Pro38 BULLETIN

Forward Closure Failures

June 15, 2016

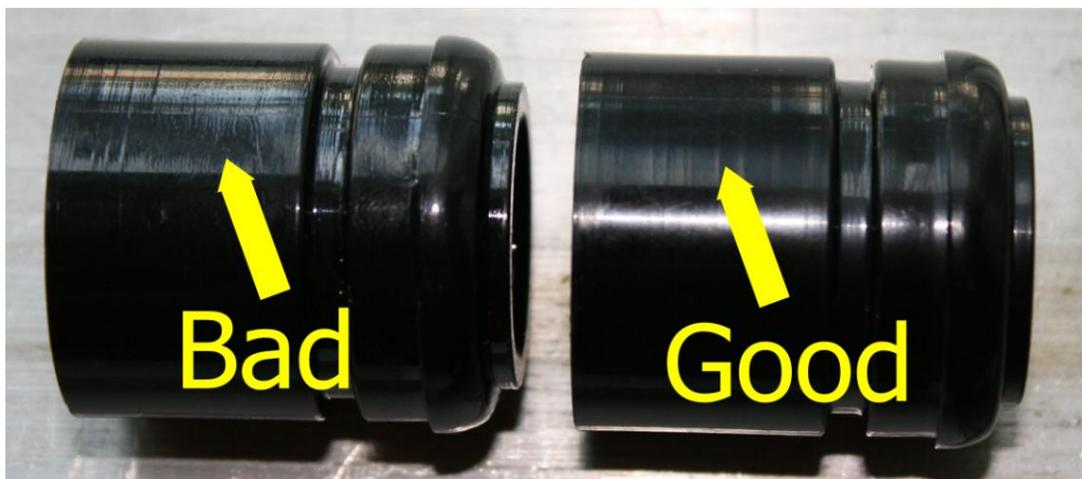
It has been brought to the attention of Cesaroni Technology Inc this past week that there has been a high failure rate on several types of Pro38 motors due to forward closure failures. Upon investigation, the root cause has been identified as a failure from de-bonding between the adhesive/epoxy and the forward closure wall. This adhesive is used to hold the delay grain within forward closure housing, and when a poor bond occurs under pressure this can lead to hot gases tracking through forward closure interface resulting in the failures shown.

Again not all of these ProX reloads will necessarily have faulty/bad forward closures. However CTI understands the work & effort the HPR community places into their model rockets and how devastating it can be if a failure occurs. As such to rectify this issue CTI will supply all of the listed dealers with replacement forward closures. Any HPR customer who believes they may have a "potentially" affected forward closure can contact their ProX dealer where they purchased the reload. The dealer will provide at no cost the replacement forward closure. Please identify to your dealer in advance the exact reload model number to receive the appropriate forward closure/delay module. Please dispose of the faulty forward closure/delay module as outline in the instructions and SDS.
